Road Safety Audit Report

Incorporating
Stage 1 Completion of Preliminary design

The Old Dairy Littlehampton

Job no	4429	Issue no	3	Date	16 th December 2013
Prepared by	JJF	Verified by	JCB	Approved by	JJF
Filename and Path	S://admin/4429/reports/4429-ITR-JJF-RSA-A.doc

site access

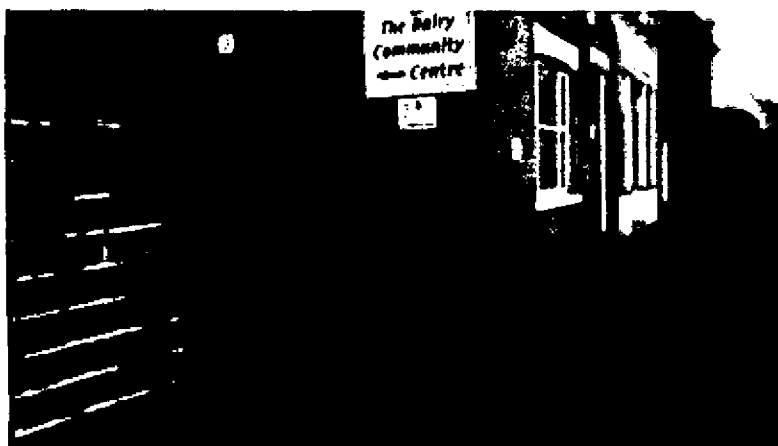
dlt n No.	Audit Team Observation	Audit Team Recommendation	Designer / Scheme Response
2	LOCAL ALIGNMENT		
.1	<i>The proposals do not have an impact on the alignment of Church Street and therefore no road safety concerns with regard to Local alignment have been raised at this stage.</i>		
3	JUNCTIONS		
.1	Problem <i>Restricted visibility</i> Accident Type <i>Vehicle Collisions</i> Location <i>Church Street west of the existing access</i> Although vehicles were observed to be travelling at low speeds in proximity of the access, visibility to the west is restricted by the adjacent boundary. Restricted visibility could lead to a vehicle egressing the site when it is not safe to do so.	A speed survey should be undertaken and visibility increased if necessary.	The alignment of Church Street to the west and the presence of the on-street parking bays adjacent to the site result in vehicles not travelling along the channel line and therefore visibility is sufficient, ref: paragraphs 10.6.1 and 10.6.2 of Manual for Streets II.

Pedestrian visibility from the east

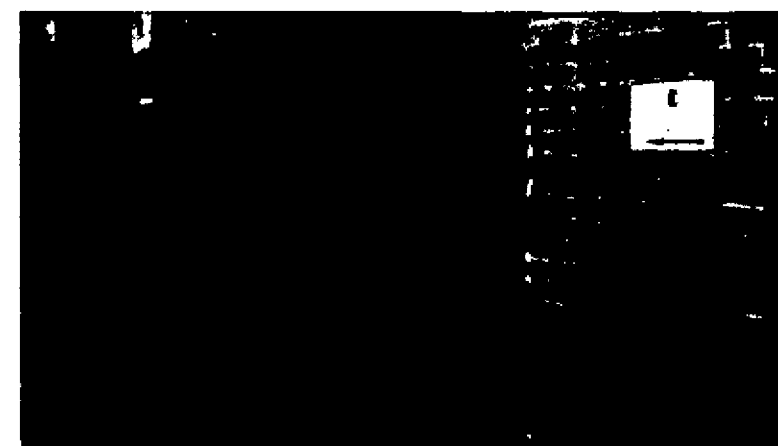
dit n No.	Audit Team Observation	Audit Team Recommendation	Designer / Scheme Response
I	NON-MOTORISED USER PROVISION		
.1	PROBLEM <i>Pedestrian visibility is restricted</i> Accident Type <i>Pedestrian/vehicle collisions</i> Location <i>Access</i> Pedestrian visibility associated with the access is restricted by No. 3 Church Street to the east and a boundary wall/hedge to the west. This could result in collisions where pedestrians and vehicles do not have sufficient warning of each other's presence.	Pedestrian visibility in either direction should be increased.	The access is historic and observations show that vehicles approach the junction slowly as recognised at paragraphs 10.6.1 and 10.6.2 of Manual for Streets II. Furthermore, the traffic generation of the redevelopment is significantly less than the lawful use and it is not possible to increase pedestrian visibility. However, the hedge to the west could be trimmed to increase pedestrian visibility.
